**CCC Interrogatory #096**

**Exhibit G1, Tab 1, Schedule 1, p. 9**

**Board Staff Interrogatory #238**

**Board Staff Interrogatory #242**

**Chart 1 – HIM Revenue**

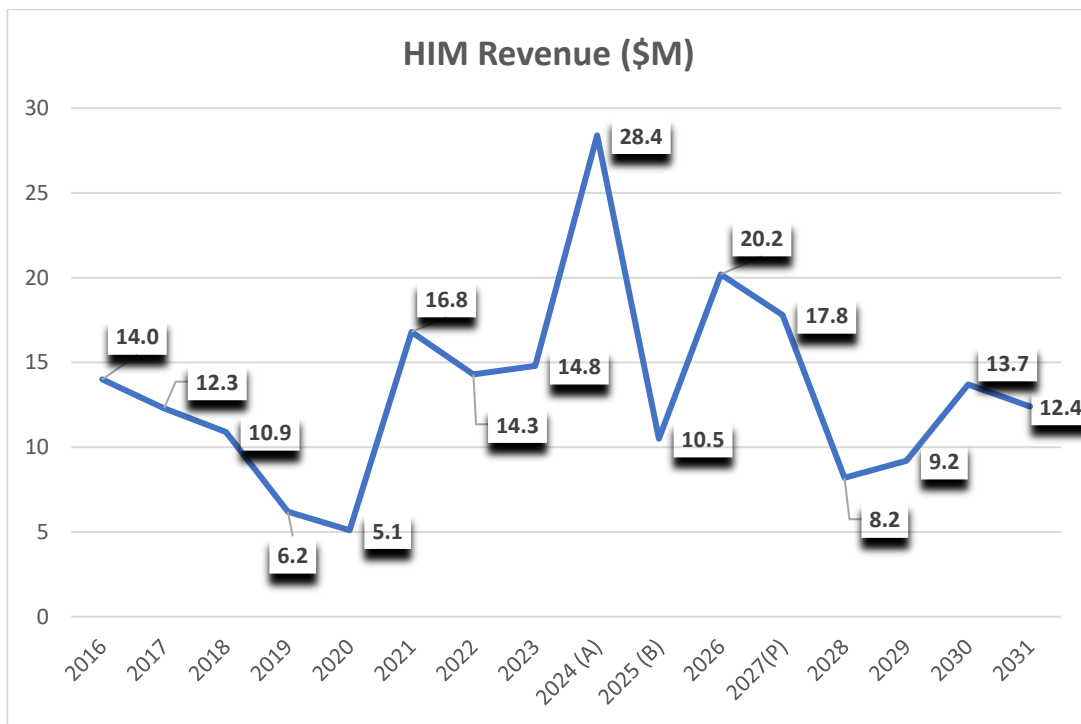
- a) Please explain the key driver(s) contributing to the HIM revenue volatility with almost a six-fold increase from 2020 to 2024 in actual revenues – \$5.1 million (2020) to \$28.4 million (2024) – followed by forecast revenues involving almost a three-fold decline to \$10.5 million (2025) and then almost a two-fold increase to \$20.2 million (2026).

- 1 b) Please explain why OPG is forecasting a significant decline in annual revenues of  
2 over \$5 million per year during the IR term (with annual average forecast revenues  
3 during the five-year IR term at \$12.3 million, while the annual average is \$17.6  
4 million over the five years before the IR term).

- 11  
12 a) The most significant driver of HIM revenue volatility is the magnitude and  
13 distribution of price spreads between on and off-peak periods in the real-time  
14 market and, after the implementation of the Renewed Market, also in the day-ahead  
15 market. These price spreads create opportunities for OPG to earn HIM revenue by  
16 following market signals. On and off-peak prices, and their relative deviation, are  
17 influenced by a variety of market conditions, including variability in supply and  
18 demand, intertie behaviour, and the impact of weather on electricity demand and  
19 hydroelectric inflows. Forecast HIM revenues are based on weather-normal market  
20 conditions and longer-term inflow trends and may differ from actual HIM revenues  
21 due to the cumulative impact of the actual values of these price drivers.

38  
39 OPG's HIM revenue forecast of \$17.8M for 2027 is in line with the annual average  
40 of \$17.6M for the five years before the IR term.<sup>1</sup> The 2027 HIM revenue reflects  
41 OPG's forecast of more moderate, weather normalized price spreads relative to

4  
5 The forecast of HIM revenues for 2028-2031 maintains the use of weather  
6 normalized inputs. Price spreads for this period are forecasted to decrease further  
7 in part due to the in-service of an additional 1,784 MW of BESS expected in 2028.<sup>4</sup>  
8 BESS operations typically involve discharging during on-peak periods and charging  
9 during off-peak periods.<sup>5</sup> On-peak discharging can displace higher-cost marginal  
10 supply,<sup>6</sup> placing downward pressure on on-peak prices, while off-peak charging  
11 increases demand during lower-priced hours, placing upward pressure on off-peak  
12 prices. Collectively, BESS operation is expected to narrow the spread between on-  
13 peak and off-peak market prices and therefore reduce HIM revenues.  
14
